# **REVIEW OF APPLICATION FOR RE-CERTIFICATION BY THE LOW IMPACT HYDROPOWER INSTITUTE OF THE DEERFIELD RIVER HYDROELECTRIC FACILITY, LIHI #90**

Prepared by Patricia McIlvaine  
February 26, 2021

Figure 1. 2019 flows in the East Branch Deerfield River below Somerset Dam. Note the flat nature of the hydrograph, especially between July and December.

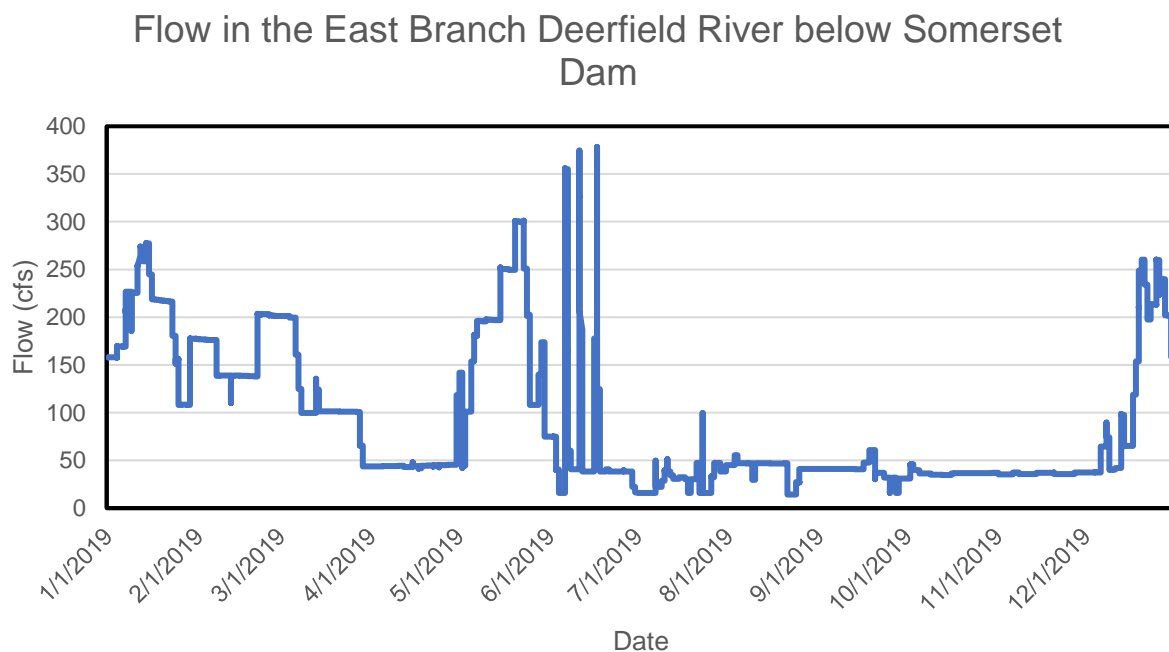
**3.2.1 Criterion A - Ecological Flow Regimes-** The East Branch Deerfield River below Somerset Reservoir partially meets the A2 Standard of Agency Recommendation. Minimum flows in this section of the East Branch Deerfield River were established by an IFIM study conducted to support development of the 401. Minimum flows were set at 12 cfs from May 1- July 31 (or 9 cfs if inflows are < 12 cfs), 12 cfs from August 1- September 30, 30 cfs from October 1 – December 15, 48 cfs from December 16-February 28, and 30 cfs from March 1-April 30. While these minimum flows were determined to meet Vermont’s Water Quality Standards over 25 years ago, the Agency does not agree that this constitutes an “Ecological Flow Regime” as defined by LIHI. An ecological flow regime as defined applies an ecosystem-based approach that supports fish and wildlife resources by considering base flows, daily, seasonal, and inter-annual variability, high-flow pulses, and short-term rates of change (Figure 2). The East Branch Deerfield below Somerset is a hydrologically altered system, primarily due to its lack of natural floods. It is not subject to daily peaking cycles or major low-flow extremes, and in many respects presents an overly static flow condition that theoretically could benefit salmonid recruitment and survival. However, it is unclear how the loss of floods and/or the presence of the dam has affected river morphology below Somerset Reservoir, and whether this exacerbates the system’s naturally low productivity. Reduced peak discharges and generally stable flows produced by regulated water releases from flood control or storage reservoirs (Figure 1) inevitably impact natural stream processes including channel morphology and substrate composition. The Agency believes that such high level of flow alteration in the Deerfield watershed should not warrant certification under LIHI.

Figure 3. 2019 flows in the bypass reach of the Deerfield River below Searsburg Dam. Note the low base flows punctuated by periodically high spill flows.

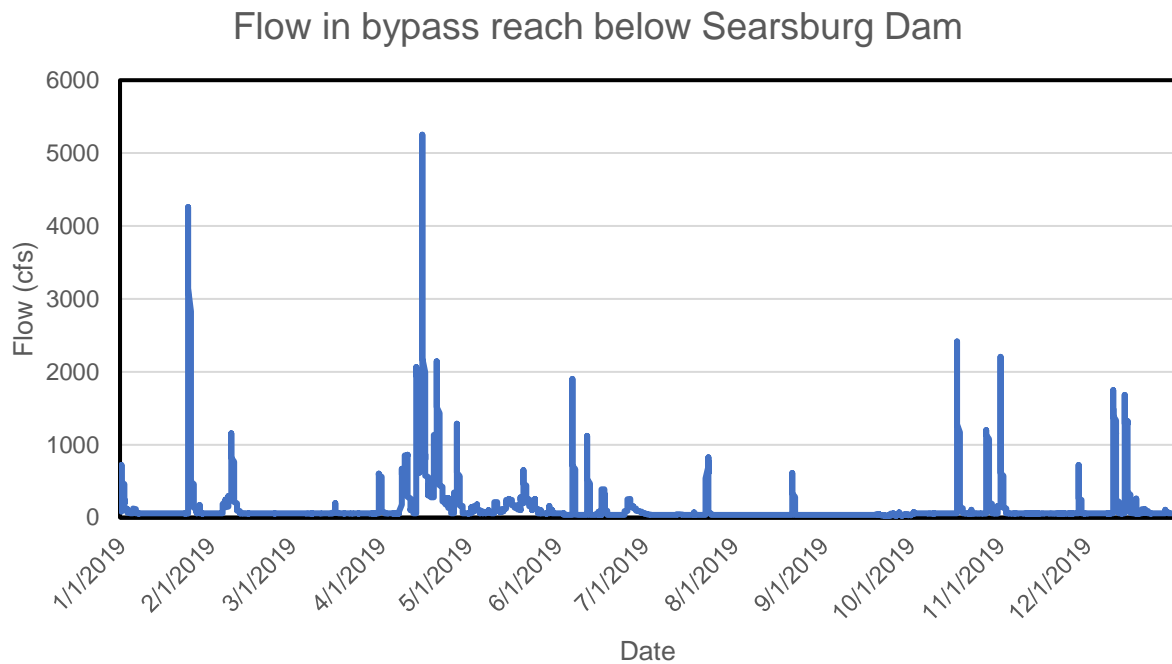
and then declined in June (Figure 4). While flows in the bypass reach tended to be lower overall, they were punctuated by peak flows approximately 1.5 times higher in the unregulated river (Figure 3). In the bypass reach below Searsburg Dam, such high flows could lead to scour and displace fish.

Figure 5. 2019 flows in the tailrace of the Deerfield River below Searsburg Dam. Note the higher frequency of flow fluctuations as compared to the unregulated North River (Figure 4).

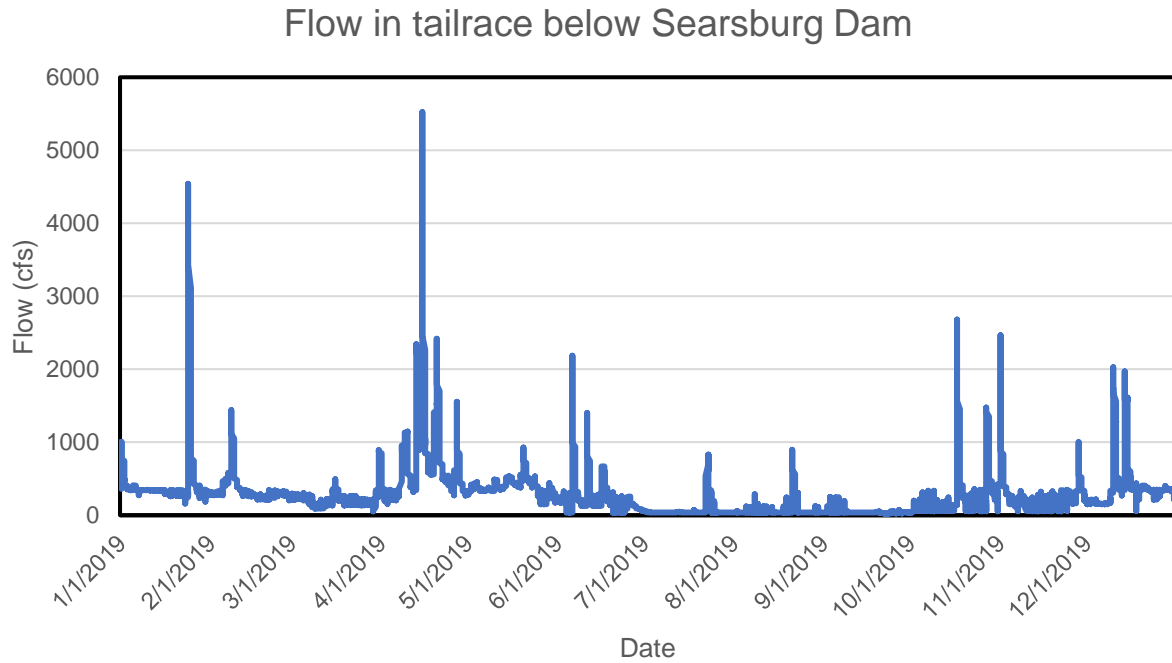
**3.2.1 Criterion A - Ecological Flow Regimes-** The downstream reach below the Searsburg bypass partially meets the A2 Standard of Agency Recommendation. In the 1.1- mile downstream reach of the Searsburg station, 175 cfs or inflow if less, is provided from April 20 to May 15 to provide riverine spawning habitat for smelt originating from the Harriman Reservoir. While these flows provide spawning habitat for smelt, this short river reach experiences flow fluctuations throughout the year because of daily peaking from Searsburg Station (Figure 5). While these spring flows mitigate the impact of hydropeaking on smelt spawning, they do not constitute an ecological flow regime because the frequency and magnitude of flow fluctuations in the tailrace are significantly higher than experienced in a natural flow regime (Figure 5). In the unregulated North River, for example, flows in October 2019 were at baseflow until precipitation events in the latter half of the month increased flows (Figure 7). Meanwhile in the Searsburg downstream reach, flows fluctuated daily in response to peaking operations (Figure 6). When the rains arrived in the latter half of month, flow peaks were significantly higher in the Searsburg downstream reach than in the North River which has a similar drainage area. While flows in the Searsburg downstream reach complied with the Water Quality Standards at the time of certification, the increased frequency and magnitude of peak flows represents a departure from the natural flow regime that impacts the ecological integrity of the river.

Figure 8. 2019 flows in the bypass reach of the Deerfield River below Harriman Dam. Note the stable flows lacking variability.

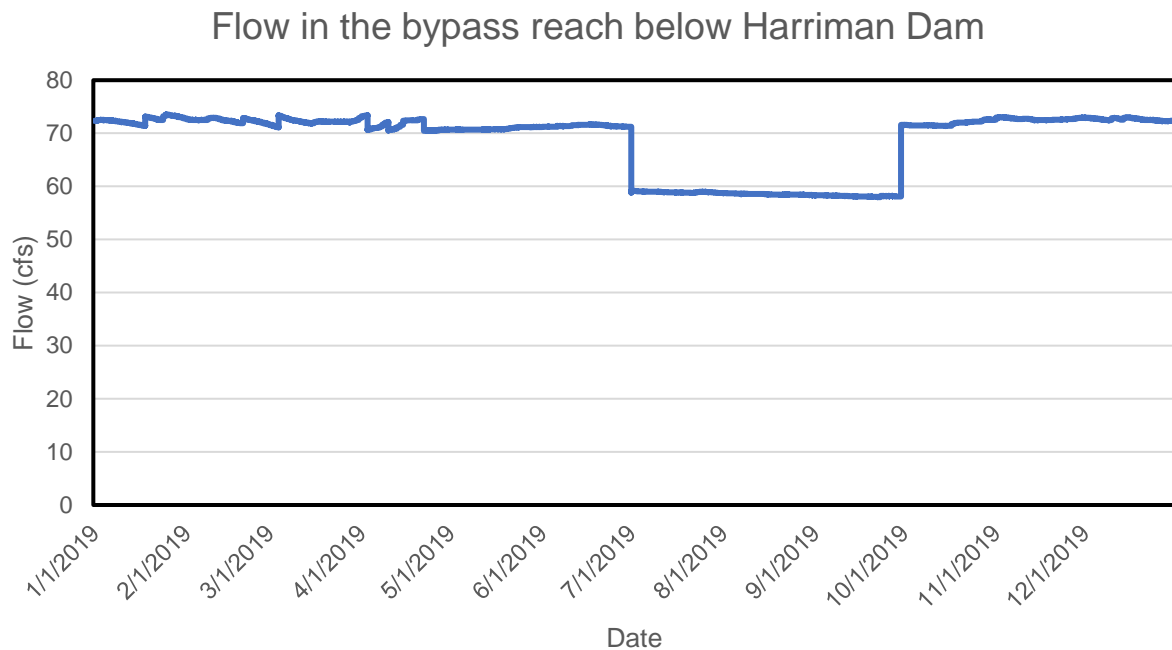
(adjusted for watershed area) fluctuated between 5 and 23,040 cfs during 2019 (Figures 9 and 10), flows in the bypass reach remained constant (Figure 8). Median flows in the New Haven River adjusted for watershed area were 347 cfs compared to 72 cfs in the bypass reach below Harriman Dam. Right below this long bypass, the tailrace is influenced by the backwater from Sherman Reservoir.
